General Bid Bulletin No. 27
14 September 2021

**THE MALOLOS-CLARK RAILWAY PROJECT AND THE NORTH-SOUTH RAILWAY
PROJECT SOUTH LINE COMMUTER PACKAGE CP NS-01: PROCUREMENT OF
ELECTRICAL AND MECHANICAL SYSTEMS AND TRACK WORKS (IFB No: 21-040-3)**

This General Bid Bulletin is issued to amend/clarify certain provisions in the Bidding Documents for the above-mentioned Project. Please refer to the attached Annexes of this General Bid Bulletin for details:

N41.02 Shunting Locomotive (Engine Type)

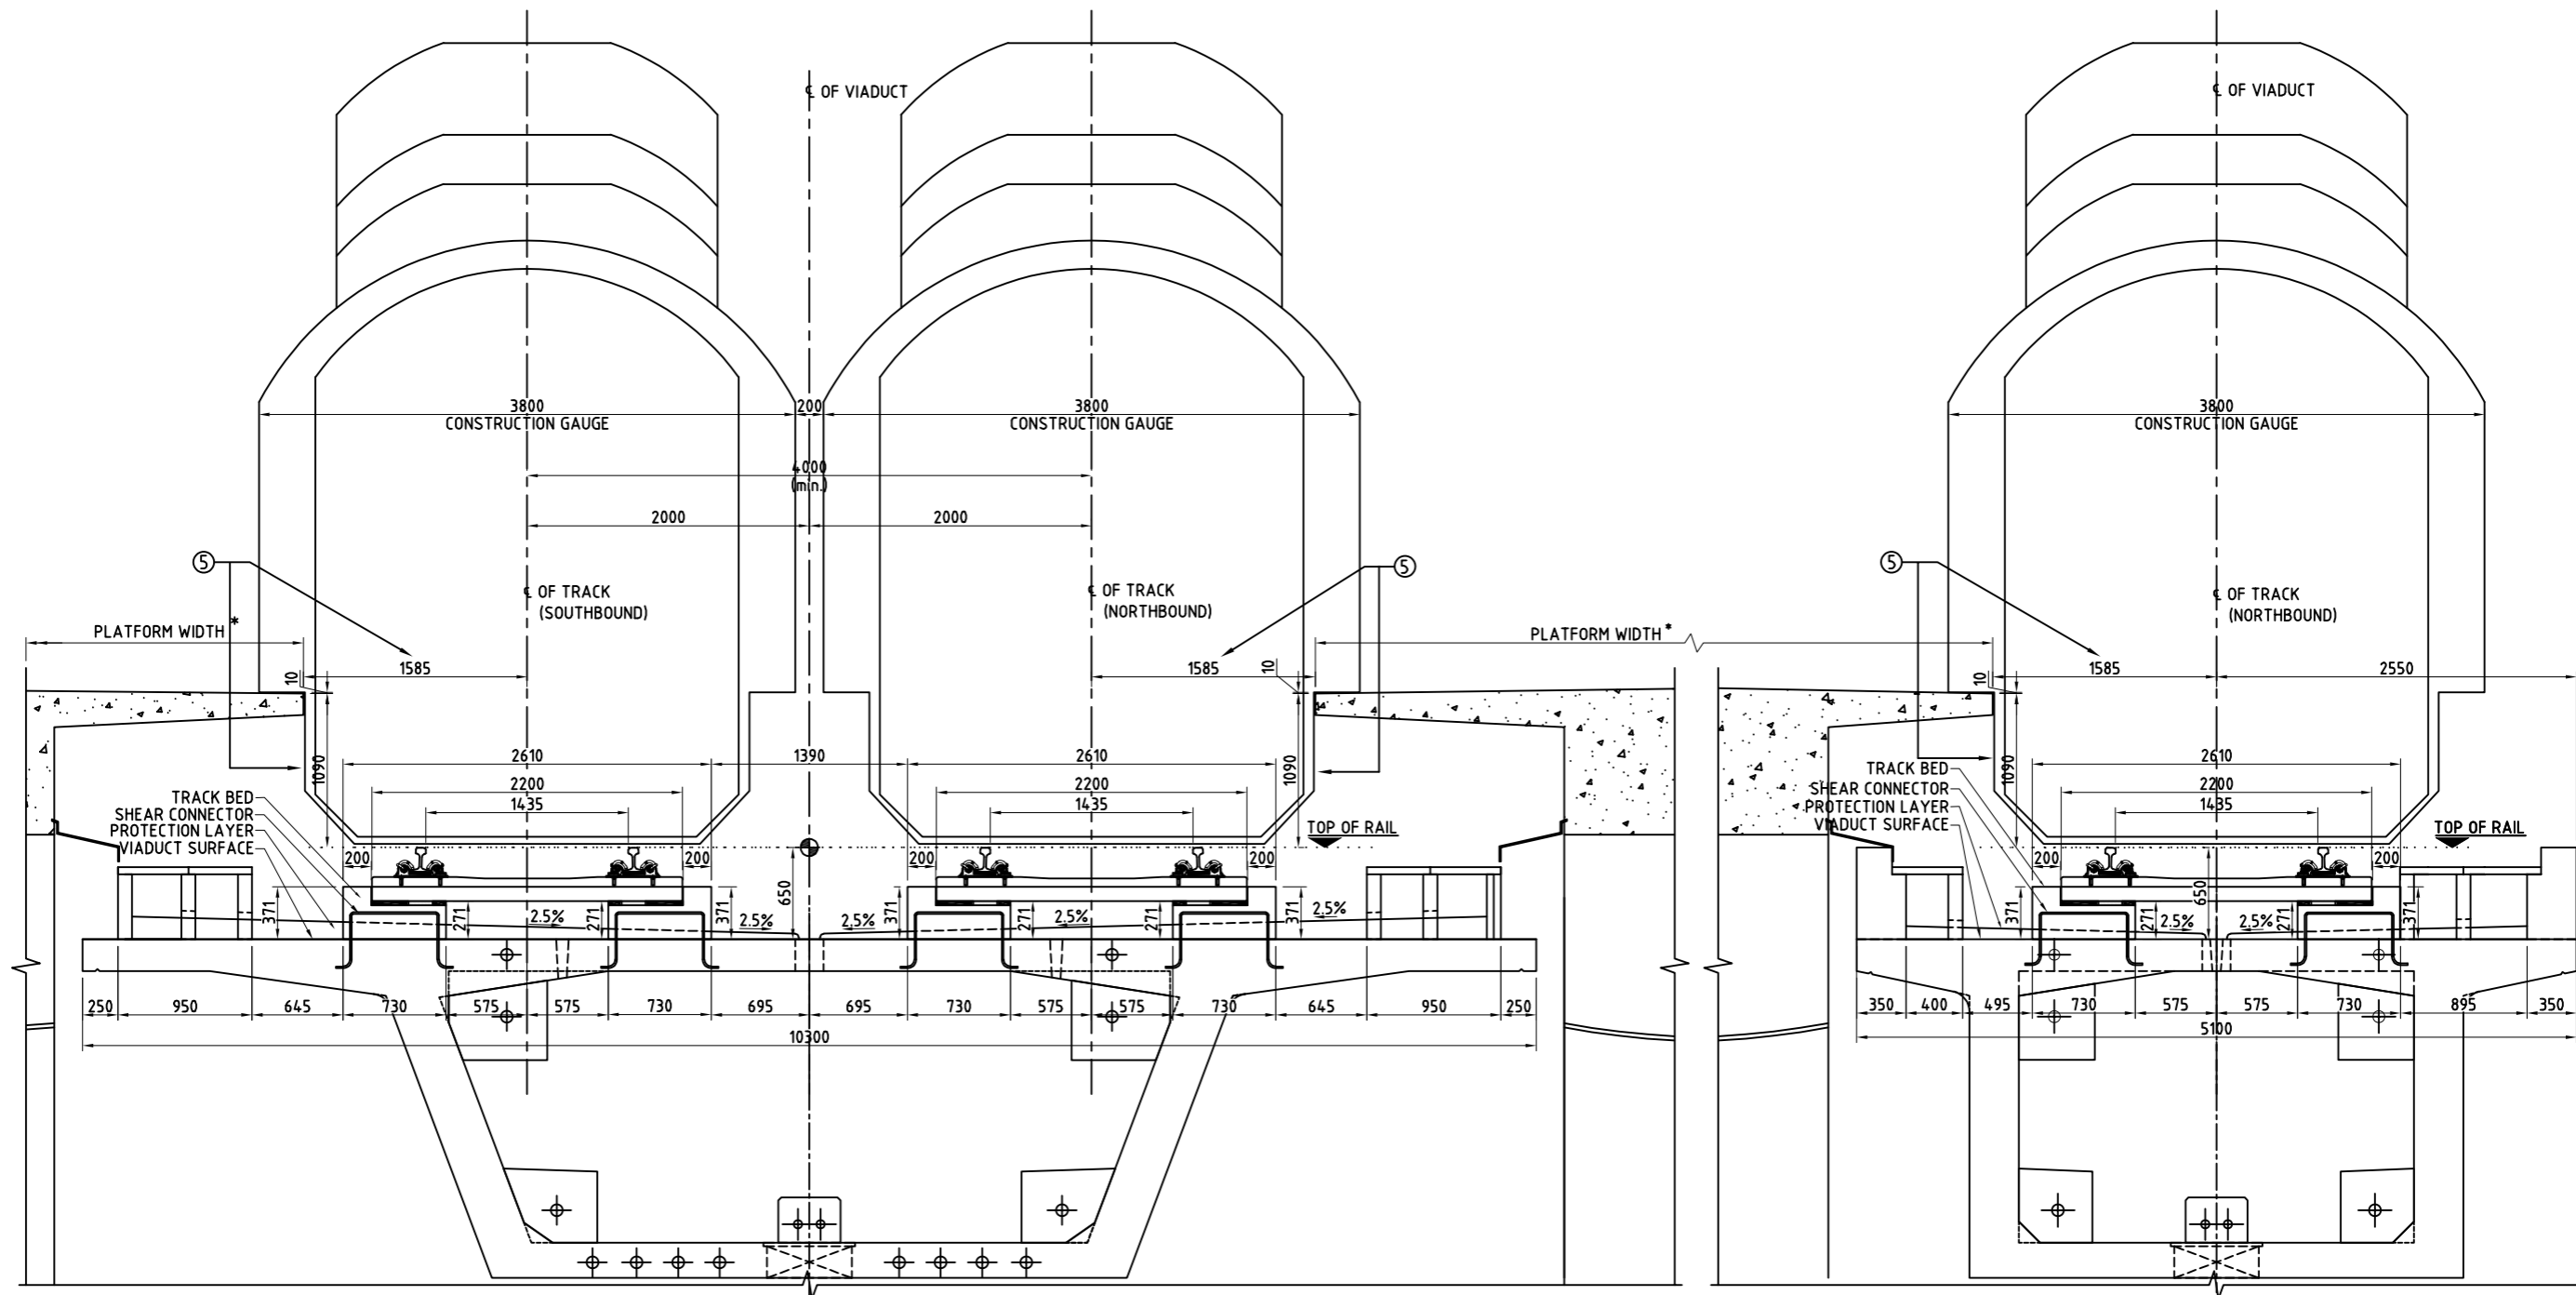
Page ERT-793	4(iv). Embedment of track rails for car body moving, floor loading (t/m2) and floor flatness.
15	Chapter 8, Part A of Appendix 8.1, N41.02 Shunting Locomotive (Engine Type), Page ERT-941	Revised Clause 2.2 to read as: 2.2 Contractor shall supply diesel locomotives (2 units) along with one flat car suitable for mainline operations having maximum 2.95m wide, to recover failed train, 315t, on 3.5% gradient. Locomotives should be able to work in both single and in multiple mode as a consist of two locomotives as per the operational requirement.
Volume III Part 2 – Employer’s Requirements d) Employer’s Drawings		
16	GBB 22 Annex B, Item no. 41	Revised drawing: DWG No. MCRP-DWG-PSS-1001 Rev.08 Traction Power Feeding System
17	Volume III Part 2- Employers Requirement Drawings (a) page 40	Revised drawing MCRP-DWG-GEN-TK-0122 Rev. 04 Typical Cross Section For Elevated Section (Station)

- 2.2. Contractor shall supply diesel locomotives (2 units) along with one flat car suitable for mainline operations having maximum 2.95m wide, to recover failed train, 315t, on 3.5% gradient. Locomotives should be able to work in both single and in multiple mode as a consist of two locomotives as per the operational requirement.
